Environmental Assessment for the Proposed HIO 13R-31L RSA Improvements

Appendix B: Modification of Airport Design Standards (MOS) for Hillsboro Airport, March 2016

MODIFICATION OF AIRPORT DESIGN STANDARDS

1. AIRPORT: Hillsboro Airport	2. LOCATION(CITY,STATE): Hillsboro, Oregon	3. LOC ID: HIO
4. EFFECTED RUNWAY/TAXIWAY: 13R-31L	5. APPROACH (EACH RUNWAY):13R <input checked="" type="checkbox"/> PIR <input type="checkbox"/> NPI <input type="checkbox"/> VISUAL	6. AIRPORT REF. CODE (ARC): C-III
7. DESIGN AIRCRAFT (EACH RUNWAY/TAXIWAY): GULFSTREAM IV

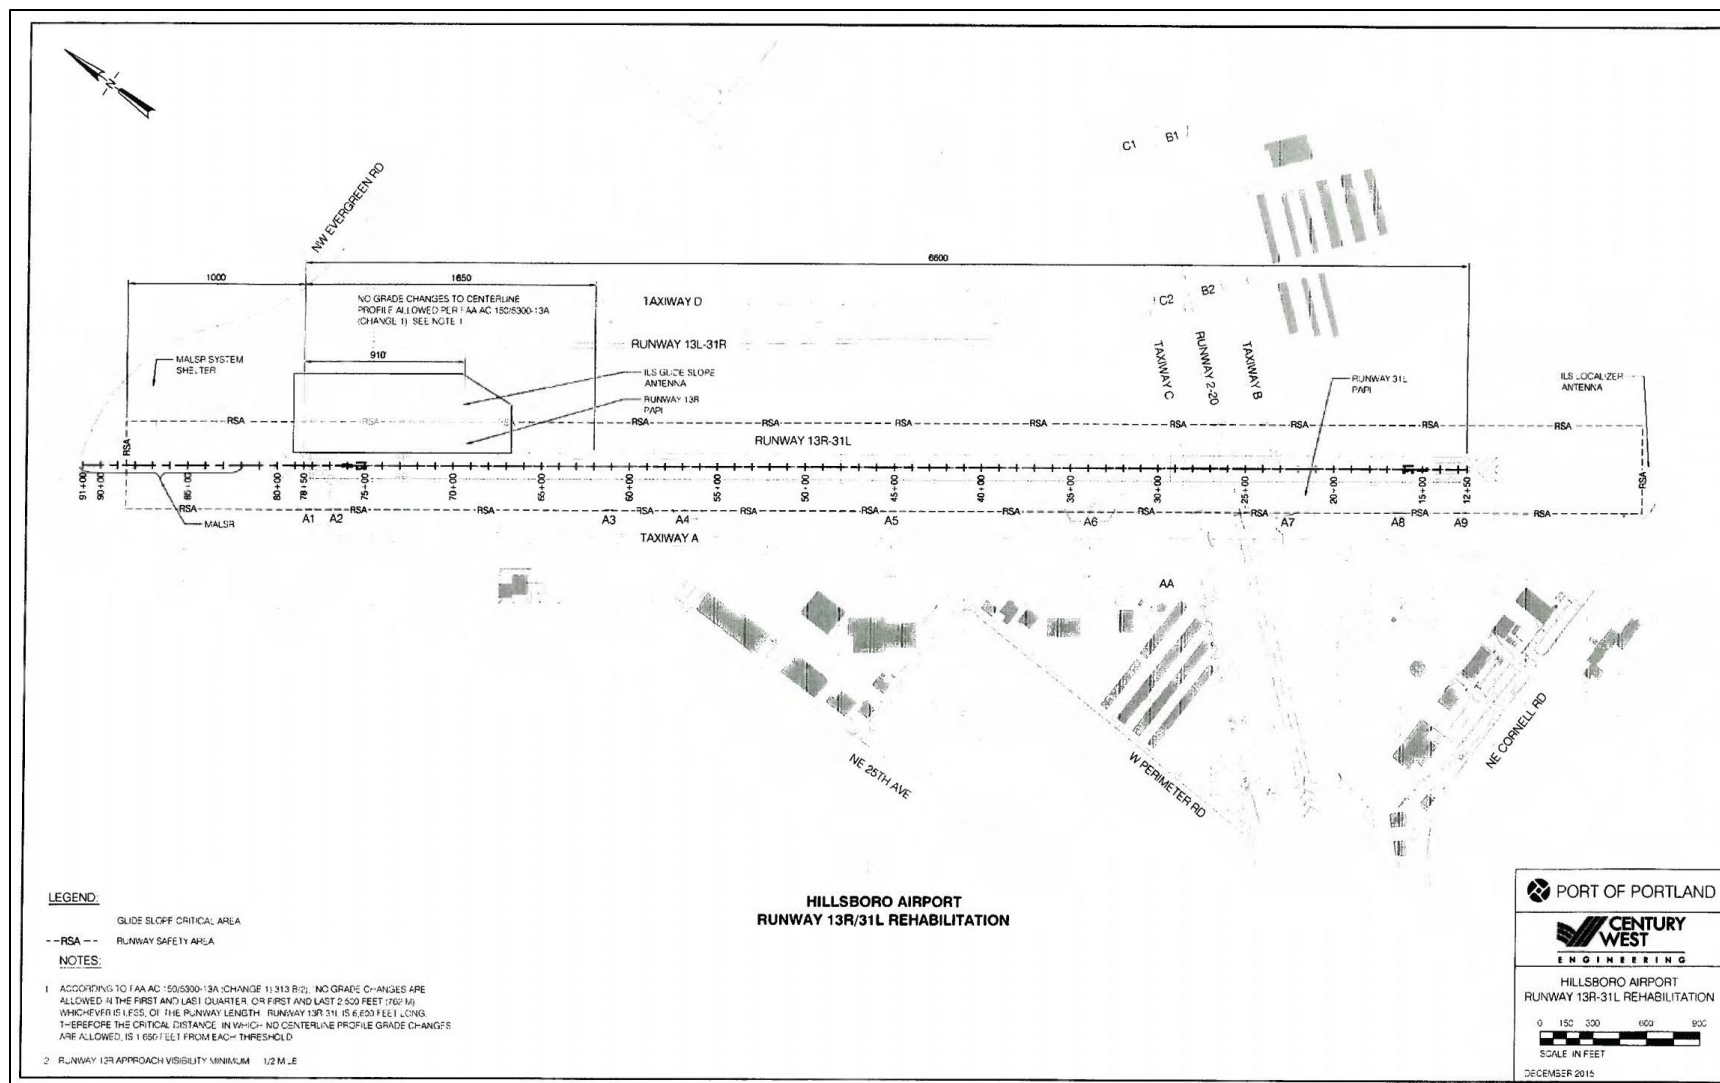
10. PROPOSED: Modification proposes to allow an existing 200 foot vertical curve, starting at 415 feet from the end of Runway 13R, to remain in place within the last quarter length of Runway 13R-31L, as part of the runway keel section rehabilitation for a limited period of time. The vertical curve would be corrected as part of the HIO Runway Safety Area (RSA) project planned for 2021.

11. EXPLAIN WHY STANDARD CANNOT BE MET (FAA ORDER 5300.1E): The keel section of the Runway 13R/31L pavement is at the end of its useful life and requires rehabilitation and/or reconstruction to safely continue operations. The runway project scheduled to start in 2018 includes proposed rehabilitation of the runway keel section in order to adequately address the existing condition of the pavement, but minimize operational impacts associated with work on the runway. The existing 13R end quarter length of runway contains a 200 foot vertical curve that joins tangent sections with a total grade change of 0.19%. This vertical curve is not permitted in this last quarter of the runway as noted in Section 10 of this Modification of Standard (MOS) document. The tangent sections are - 0.075% and -0.270%; no longitudinal grade in this last quarter exceeds the maximum allowed 0.8 percent. See the attached Runway 13R/31L Profile plan sheet that shows the existing centerline profile at the 13R end of the runway. This precision instrument runway end does have an Instrument Landing System (ILS) with a MALSR and a glide slope, with the glide slope antenna located 910 feet from the Runway 13R end. The Runway 13R ILS approach visibility minimum is ½ mile. See the attached Runway 13R/31L Plan sheet that

shows the airfield NAVAIDS and glide slope critical area at the 13R end of the runway. The keel rehabilitation approach requires the centerline profile to follow the existing runway grade in order to match the existing outer runway edge and shoulder grades. In order to maintain runway operations following each phase of construction, existing grades must be followed in order to accommodate tie-ins at phase lines of runway and taxiway connections. As discussed in Section 12 of this MOS document, the more extensive reconstruction required to achieve the runway longitudinal grade correction is better accomplished in the upcoming RSA project, currently scheduled for 2021, than in the runway rehabilitation project in the coming years, since scheduling the projects the way they are proposed will greatly minimize the total extent and cost of reconstruction required on the runway and the adjacent connector taxiways. The proposed runway centerline profiles for the RSA project and the full width runway reconstruction project are shown on the attached Profile plan sheet. Given the regrading needed in the RSA off the runway end, the schedule identified in Section 12 as the preferred alternative is the most logical way to sequence the regrading of the runway in order to get the longitudinal grade to meet standards.

MODIFICATION: 1		LOCATION: HIO		PAGE 2 OF 2	
14. SIGNATURE OF ORIGINATOR:  1/28/16		15. ORIGINATOR'S ORGANIZATION: Port of Portland		16. TELEPHONE: 503-415-6395	
17. DATE OF LATEST FAA SIGNED ALP: April, 2012					
18. ADO RECOMMENDATION: Conditional Approval		19. SIGNATURE: 		20. DATE: 2/2/16	
21. FAA DIVISIONAL REVIEW (AT, AF, FS):					
ROUTING SYMBOL	SIGNATURE	DATE	CONCUR	NON-CONCUR	
ANM-622		3/3/2016	X		
ACG-220 See attached					
COMMENTS: Conditional approval by The Region acceptable per Khalil Kadi The airport agrees to take corrective actions as stated within Box 12 of this MOS. 11/6/2016					
22. AIRPORTS' DIVISION FINAL ACTION:  ANM-622 3/3/2016					
<input type="checkbox"/> UNCONDITIONAL APPROVAL		<input checked="" type="checkbox"/> CONDITIONAL APPROVAL		<input type="checkbox"/> DISAPPROVAL
